## TECHNICAL NOTE

**Re:** Project Metrolink - Refined Phase IIa Building Damage Assessment for Arthur Cox Building at 13-14 Earlsfort Terrace

**Date:** 26/2/2024

**Ref:** 22-232A-TN01

Figure 3-3 Tunnel alignment superimposed on plan of the basement and perimeter secant pile wall.

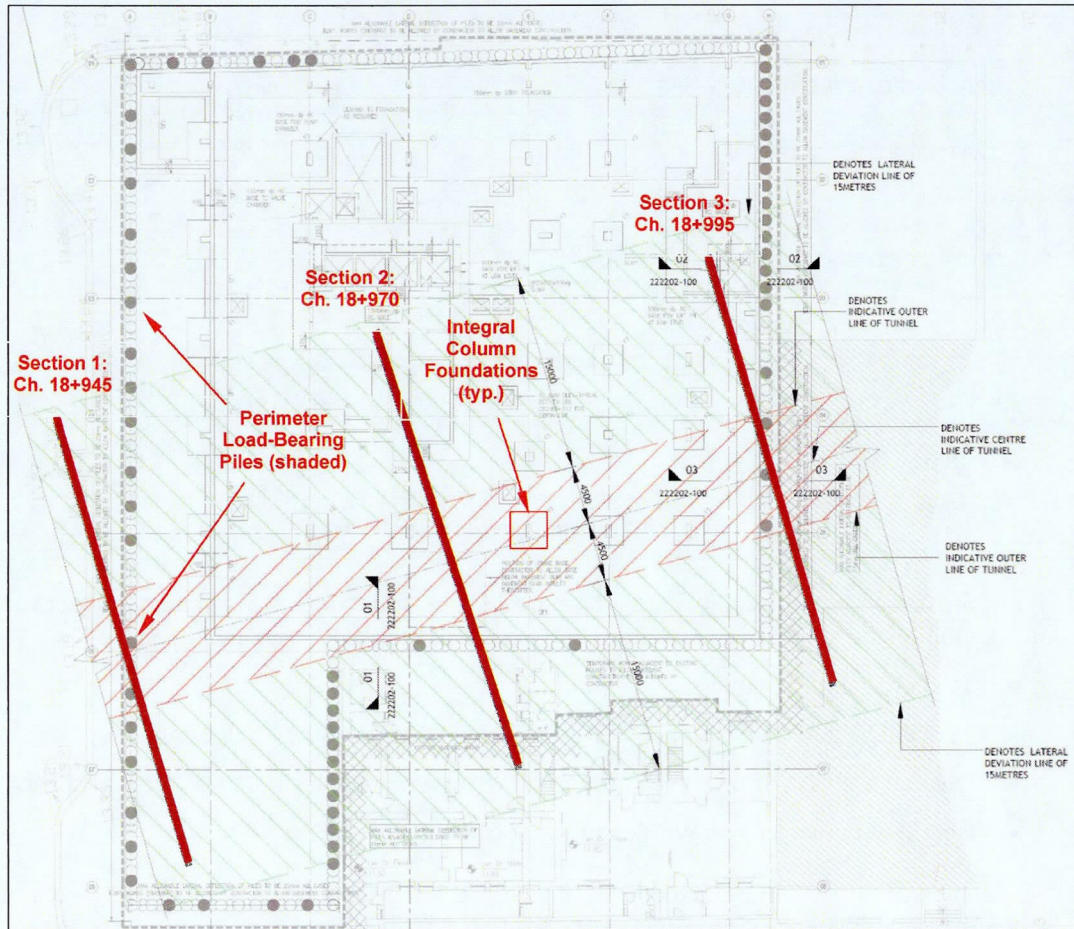
Figure 3-3 shows the proposed tunnel alignment superimposed on a plan drawing of the basement and perimeter secant pile wall of the building. The figure identifies where there are load-bearing piles in the perimeter wall (shaded) which support concentrated loads from the building façade and internal reinforced concrete (RC) structure. It also shows where the basement slab has been locally thickened to create integral pad foundations for the internal columns of the building. A copy of the drawings is included in Appendix A.

The locations of these sections is shown on Figure 3-3.

Figure 4-2 Geological Cross-Section [Sheet 26 of 28 from Appendix A20.9 to Chapter 20 of the EIAR]

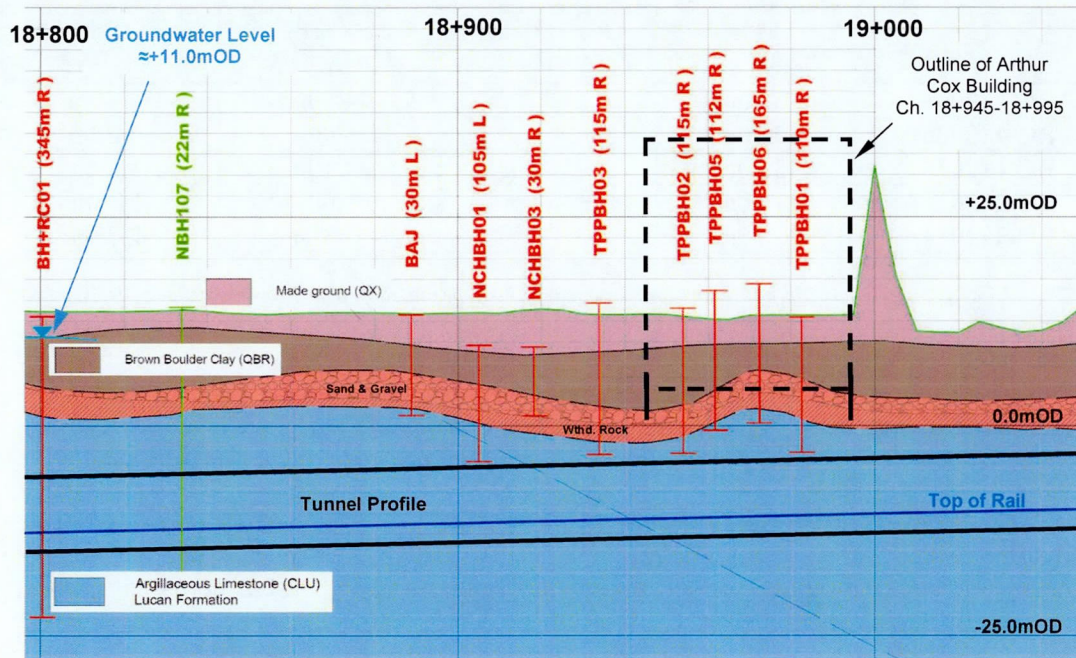
- None of these boreholes are identified on the geological cross section in Figure 4-2. All of the site investigation points that are shown on the profile were terminated above the level of the tunnel and were located 115-165m to the right (west) of the tunnel alignment.

- None of the logs for the investigation points shown on the location plans or geological sections were included in the EIAR so it is not possible to verify the ground conditions interpreted by Jacobs/IDOM.

The site investigations carried out on the site of the Arthur Cox Building in 2008 & 2014 indicate that the top of rock is at a higher level than shown on the geological cross section produced by Jacobs/IDOM for the EIAR (Figure 4-2) i.e.:

- 2008/2014 Ground Investigations: +4.5mOD to +7.35mOD
- Jacobs/IDOM Cross Section: +2.50mOD to -2.50mOD
